# Product Change Notification (PCN)

PCN Number	510049	Date Issued	May 14, 2021
Reason for Change	Change to Product		
Change Type Description	This letter is to inform you that changes are being made to the part(s) identified in this Notice. The change may affect the fit, form, function or appearance of the parts, or it may result in a change to the specification. The pictures below show an example of the possible differences.		
Reason for Short Notice	Corrective Actions		
Assessment of Change	Test report/Specification Test Report		
Internal Molex Qualification Date	May 28, 2021		
Sample Availability Date (Changed Part)	May 28, 2021		
Planned Implementation Date	July 01, 2021		
Method of Identifying Change	Lot information on label

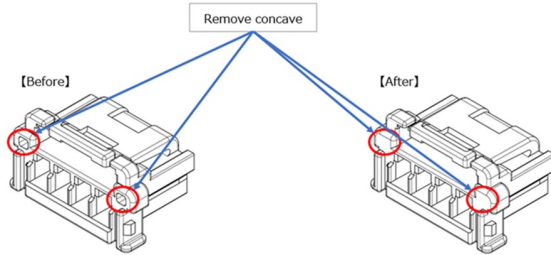
- **Change Point:**
  - Remove the concave and then return to the original size of the air venting
- **Reason:**
  - To reduce quality risks of Bubble & Gate flash
- **Product Impact**
  - Impact to cosmetic appearance. But there is no change of Fit or Function.
- **Part Number Impact**
  - 505151-0301/505151-0401/505151-0501/505151-0601/505151-0701/505151-0801/505151-0901
  - 505151-1001/505151-1101/505151-1201/505151-1301/505151-1401/505151-1501/505151-0300
  - 505151-0400/505151-0500/505151-0600/505151-0700/505151-0800/505151-0900/505151-1000
  - 505151-1100/505151-1200/505151-1300/505151-1400/505151-1500
- Qualification Reports and samples available upon request after 1<sup>st</sup> of May,2021
